South Texas Project
Units 3 and 4
Docket Nos. 52-012 and 52-013
Revised Responses to Requests for Additional Information

Attached are Nuclear Innovation North America LLC (NINA) revised responses to Requests for Additional Information (RAIs) related to Combined License Application (COLA) Part 2, Tier 2, Section 10.2, "Turbine Generator." The referenced letters collectively provided initial and supplemental responses to the RAIs. The attachments include additional information requested by NRC staff during discussions on January 5, 2011, February 2, 2011, and February 16, 2011, for the following RAIs:

RAI 10.02-1, Revision 1**QUESTION:**

RAI 10.02-2, Revision 1**QUESTION:**

Figure 10.2-5 Turbine Overspeed Trip System Functional Diagram

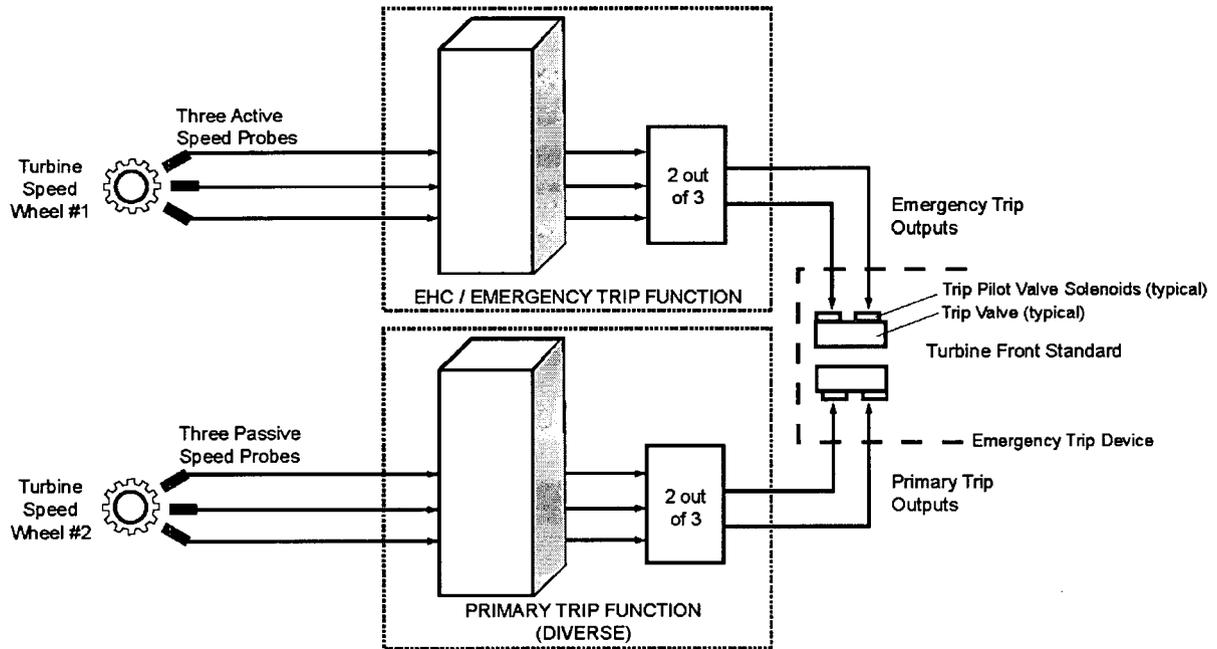
- 1) Describe the setpoints for the normal overspeed and the primary and emergency overspeed systems, with full descriptions, how they function.
- 2) Provide how the two electrical overspeed (primary and emergency) systems are diverse. Describe, and also provide schematics and logic diagrams to depict how the overspeed systems are diverse and independent.

In STP response to staff's RAI 10.2-2, the staff noted that the turbine trip set-points for the primary and emergency backup electrical overspeed systems are 110 and 111 percent of its rated speed, respectively. The staff finds these overspeed trip systems conform to the guidance specified in Items 2.C and 2.D of SRP Section 10.2.III, as related to their set-points. However, the applicant did not provide the schematics and logic diagrams for the two electric overspeed systems, as requested in the RAI 10.2-2. The staff is unable to conclude that the applicant has provided sufficient information for the two electrical overspeed control systems without these schematics and an associated ITAAC in this regard. Therefore, the staff requests the applicant to provide the following:

Based on a review of the applicant's response to RAI 10.02-4 and FSAR markup, the staff found that additional information and clarification is needed with respect to the T-G primary and emergency turbine overspeed trip subsystems. In particular, the following items need to be addressed and the FSAR needs to be updated as appropriate to include this information:

1. Section 10.2.2.4: Consistent with the response that was provided to RAI 10.02-4; the FSAR description of the turbine overspeed trip subsystems needs to be revised to distinguish which parts are independent, redundant and diverse from those that are independent and redundant. Also, from the response it is not clear which of these two categories the solenoid operated pilot valves are in and additional explanation is needed in this regard.

This response is revised as indicated with revision bars. Nomenclature has been updated for clarity and consistency with other RAI responses and the COLA mark-ups including Figure 10.2-5 (nomenclature was the only change to this figure).

The overspeed protection system consists of the diverse primary overspeed trip function and the emergency overspeed trip function, as illustrated in the attached figure. Relative to each other the primary and emergency overspeed trip functions are independent, redundant and diverse up to the trip pilot valve solenoids on the trip valves. The trip valves are redundant and independent.

The following figure will be added to COLA Part 2, Tier 2, Section 10.2.

The overspeed trip system is electrical, redundant and diverse and consists of the Primary and redundant Emergency overspeed trip functions. The primary trip function is independent and diverse from the emergency trip function as explained below (refer to Figure 10.2-5, Turbine Overspeed Trip System Functional Diagram). Reliability is

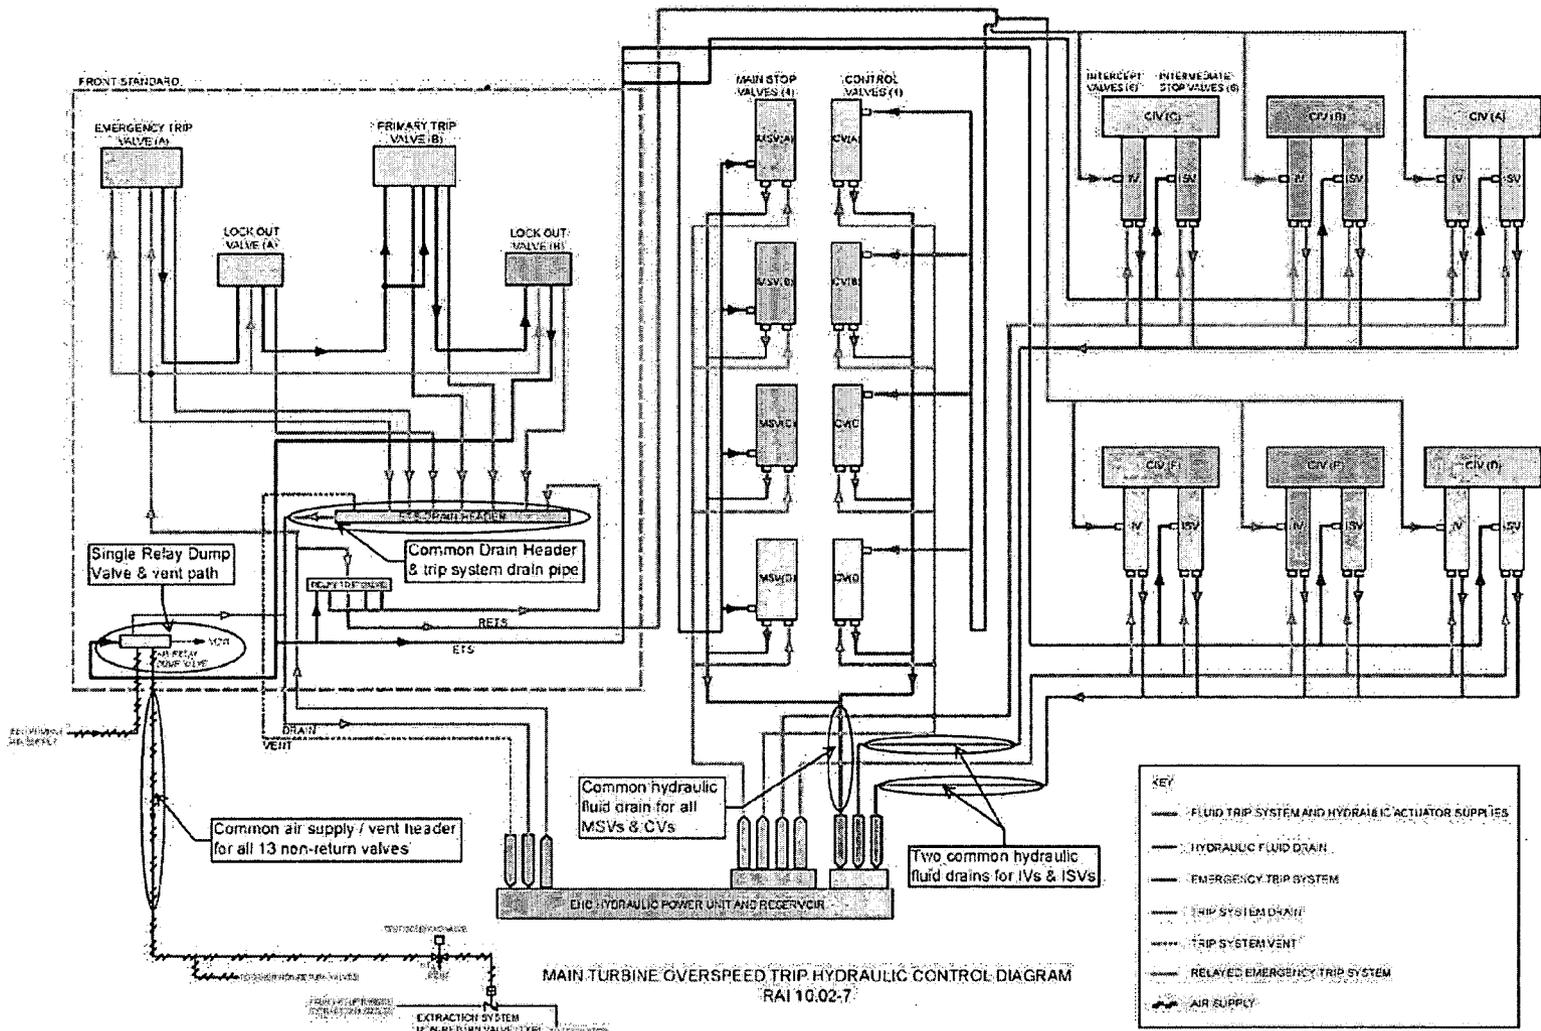
1. The description of the turbine overspeed protection systems (including air and hydraulic systems/interfaces as applicable) need to clearly indicate what parts are shared between the primary and emergency turbine trip systems. For example, shared air and hydraulic dump lines and components such as dump valves and reservoirs need to be described in the FSAR. For clarity, the response should include schematic diagrams that show these flow paths, applicable components, and valves being actuated.

- The trip valves and lockout valves drain emergency trip system (ETS) fluid to a common drain header, where it is drained to the HPU reservoir through a common drain pipe. The header drain will be a 1" nominal, or greater, pipe.

- The drain header has one vent pipe to the HPU reservoir.

Periodic surveillance testing of valves and trip devices ensure that the drain pipes are not plugged.

- There is one air relay dump valve that controls air to the steam extraction non-return valves. Venting of the air by the air relay dump valve will cause the spring assisted non-return valves to close. The instrument air system supplies clean and filtered air to the non-return valves and the relay dump valve. See COLA Part 2, Tier 2, Subsection 9.3.6 for more details of the instrument air system. The extraction non-return valves are check valves and, should the air fail to vent, they would close on reverse flow.

Although detailed design is not included in the COLA, the attached diagram is included in this RAI response for clarity.
